Our Reference: NA231578
Your Reference: MC-25-00004

Level 8,
55 Market Street,
Sydney NSW 2000

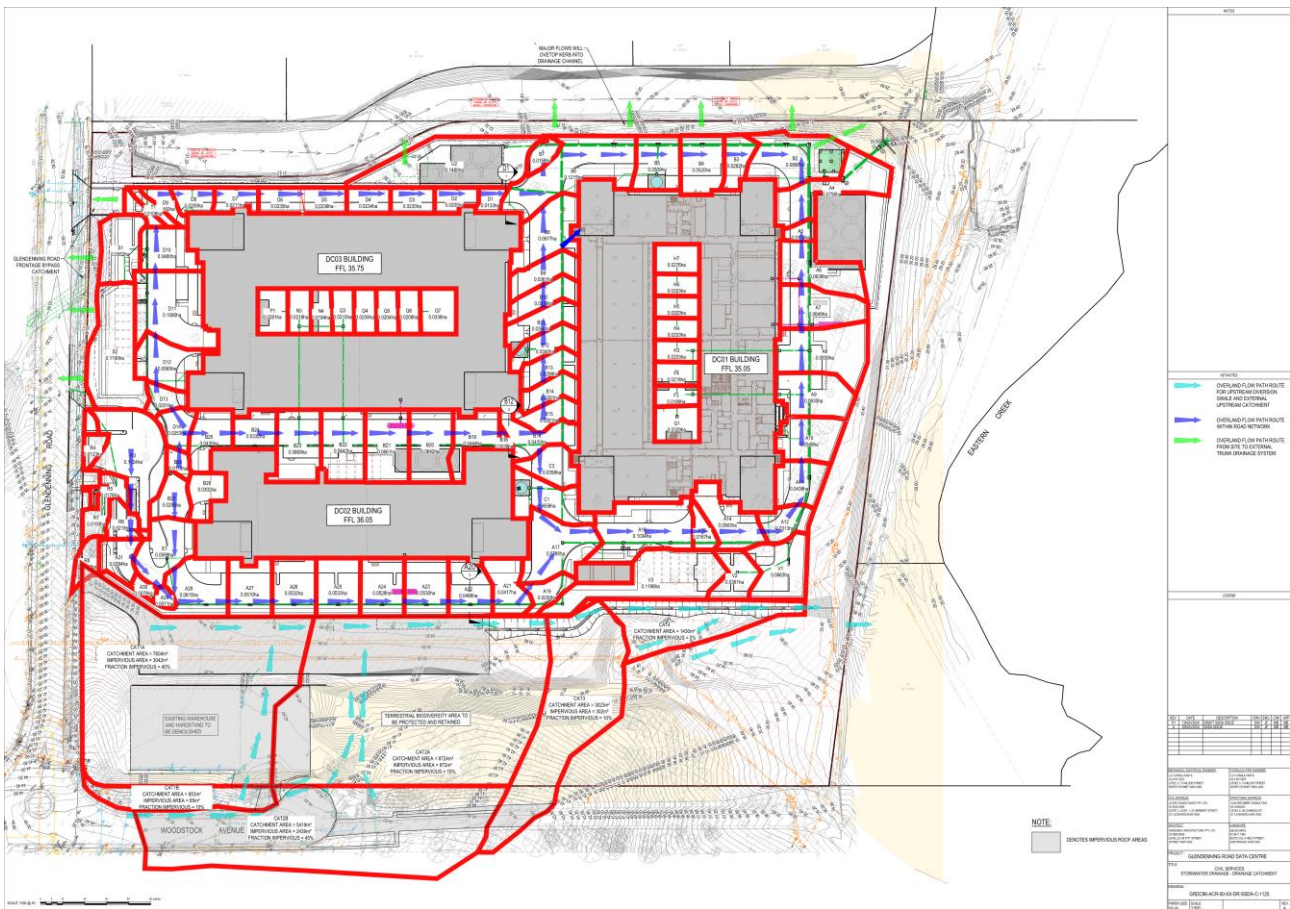
We trust the above meet your requirements at present. Please contact the undersigned if you require any further clarification.
